TO: Mayor David Still, City of Lawrenceville
ATTN TO: Todd Hargrave, Planning and Development Director
FROM: Douglas R. Hooker, ARC Executive Director
RE: Development of Regional Impact (DRI) Review

Name of Proposal: Lawrenceville Gateway DRI 3525 **Submitting Local Government:** City of Lawrenceville

DRI #3525

DRI SITE PLAN - DRI #3525
LAWRENCEVILLE GATEWAY
742 COLLINS HILL ROAD
LAND LOT 10 - 7th DISTRICT
CITY OF LAWRENCEVILLE, GWINNETT COUNTY, GEORGIA

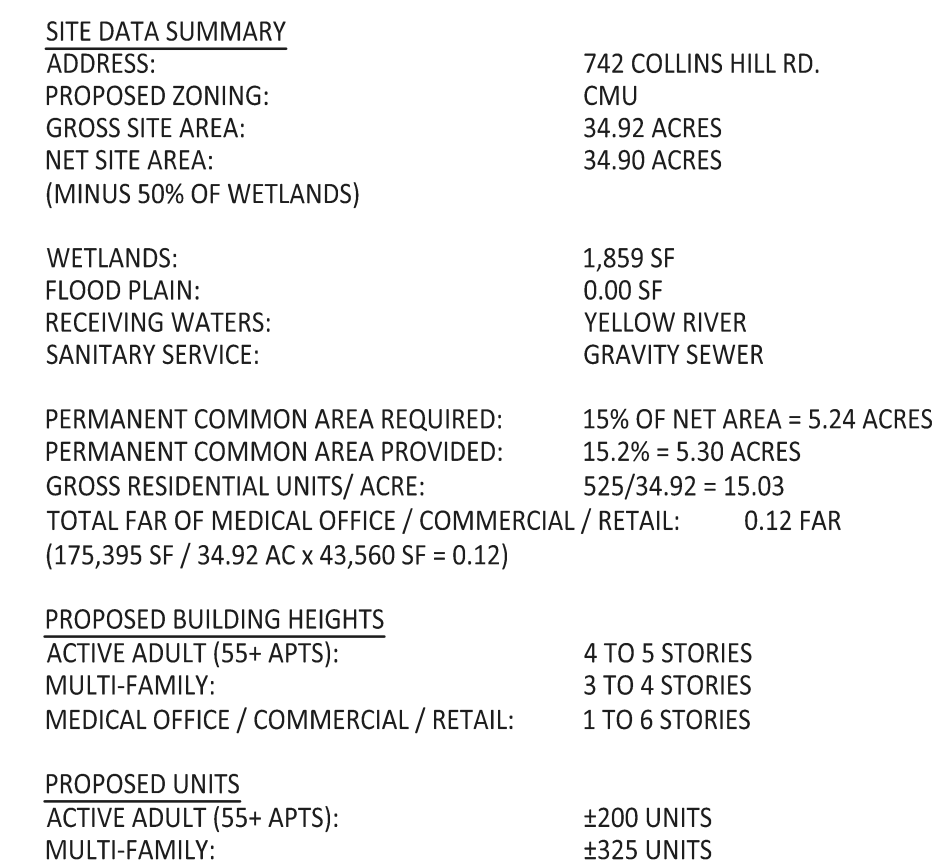
- A proposed retaining wall intrudes into the stream buffer at the SW corner of the site.
- Retention of additional existing trees would provide stormwater, urban cooling, energy use reduction, and air quality benefits.

An intermittent creek exists in the SW corner of the site which is subject to the city 50-foot stream buffer and 75-foot impervious setback, as well as the state 25-foot sediment and erosion control buffer. The plans show a proposed retaining wall within the 75-foot impervious setback. The wall, as well as any proposed mass grading, may require a variance from the City. Any other intrusions into the buffers may also require variances from the City or the State.

The project will create approximately 640 surface parking spaces. Ideally these parking areas can utilize a combination of impervious paving and canopy tree plan to capture stormwater on site and reduce heat gain. The portion of a retaining wall that extends into the 75-foot impervious surface stream buffer would ideally be adjusted to preserve the full buffer.

Both the site plan and the USGS coverage for the project area show an unnamed intermittent creek crossing the southwestern corner of the project property. The City's 50-foot stream buffer and 75-foot impervious setback, as well as the State 25-foot Sediment and Erosion Control buffer, are shown on the plans. The plans show a proposed retaining wall in the 75-foot impervious setback. The wall, as well as any proposed mass grading, may require a variance from the City. Any other intrusions into the buffers may also require variances from the City or the State. Any unmapped streams on the property may also be subject to the City and State buffers. Any unmapped waters of the state will also be subject to the State 25-foot Sediment and Erosion Control buffer.
